February 11, 2016

ADDENDUM NO. 2

#15036 – FORD FIELDS CONCESSION STAND BEAUMONT, TEXAS

Sheet ME-4.2 – Detail 1:

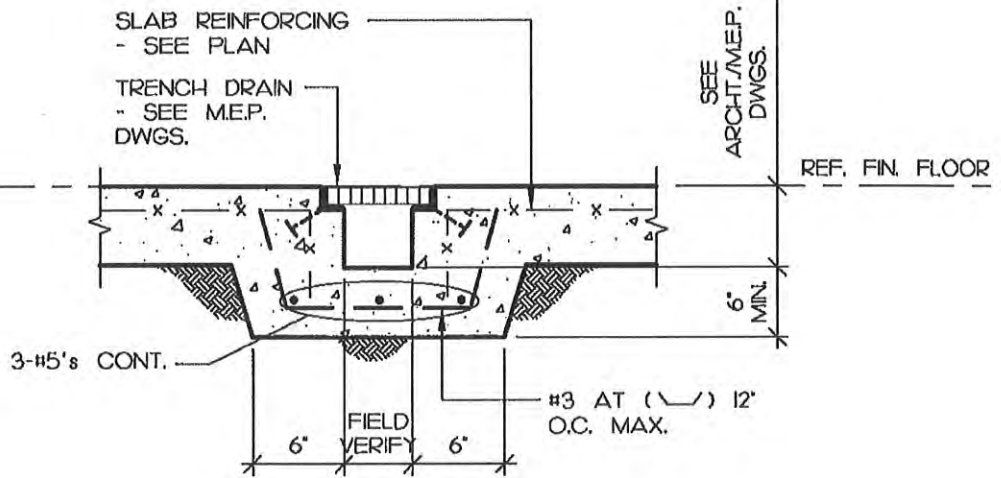
1. Delete Lighting Fixture C at north end of west wall and delete Fixture CE at center of west wall. Replace with one Fixture Mark HE in center of connecting canopy between buildings.
2. Add junction box and Circuit LD3-18 for “Sluggers Sign” on south side of building. Add wall switch adjacent existing switches for south side fixtures.

PROJECT NO.	15036
SHEET NO.	SK-1
REFERENCE TO	A0.1
ISSUE DATE	02.10.2016

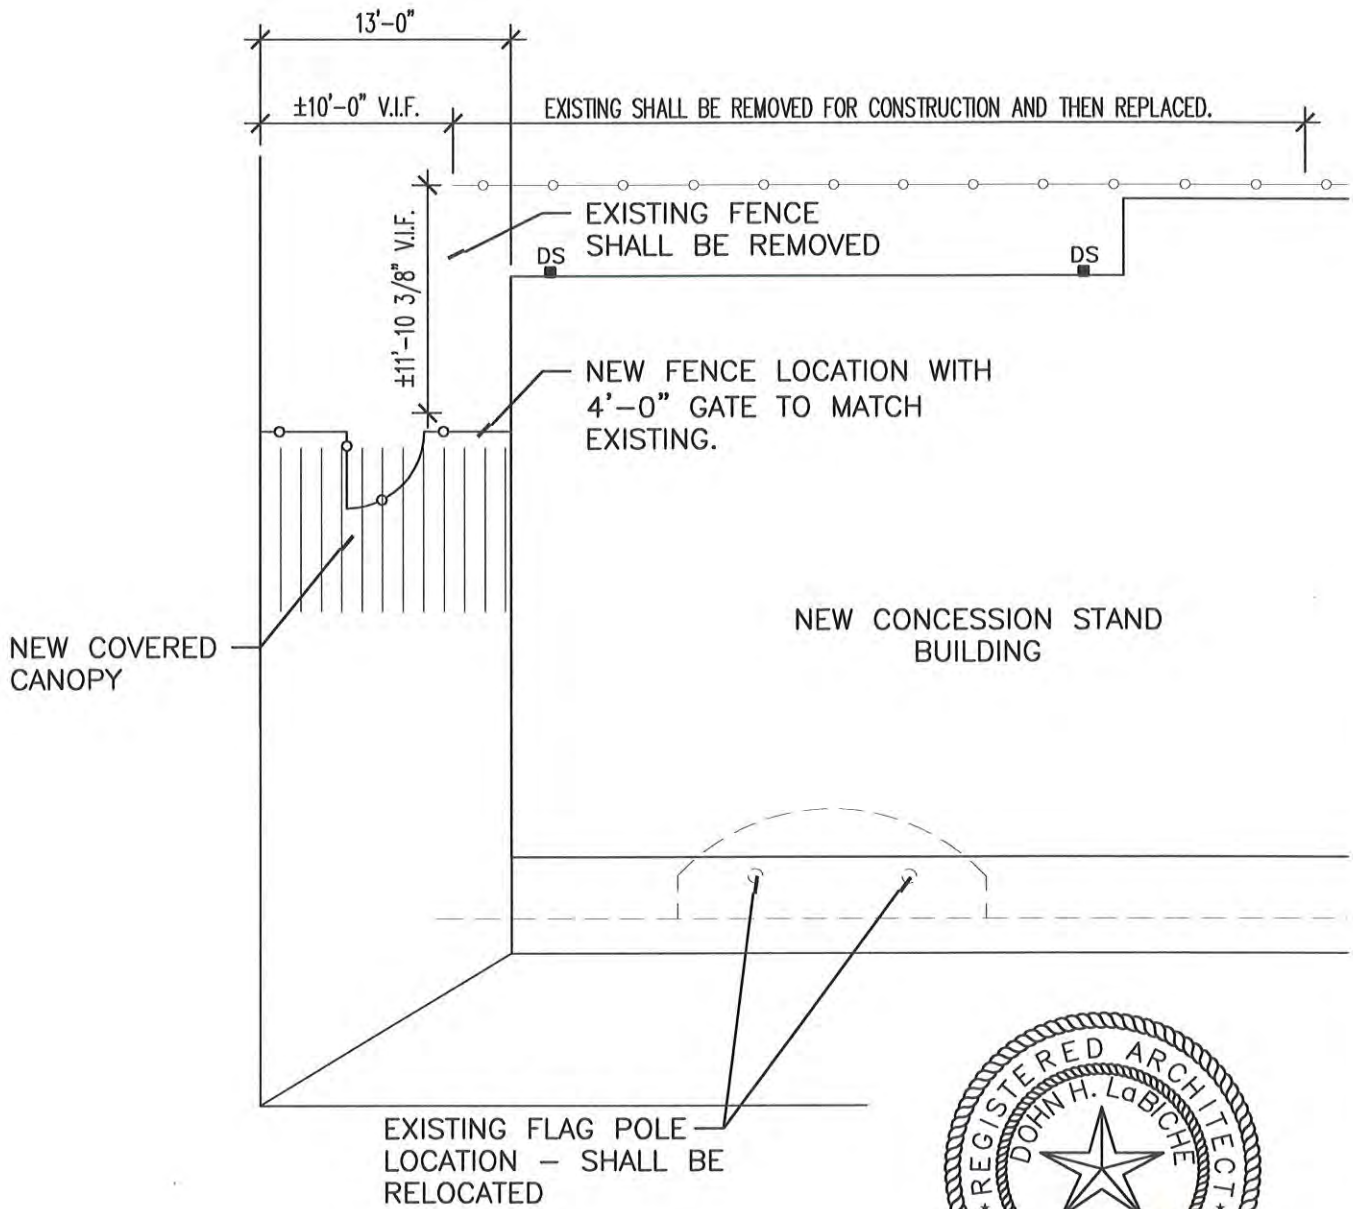
1. See the attached SK-1 for clarification of fence/gate locations. It is our assessment that the existing fence at the rear of the new Concession Stand shall need to be removed for construction and then replaced in the same location at the conclusion. There shall be no motorized gates required.
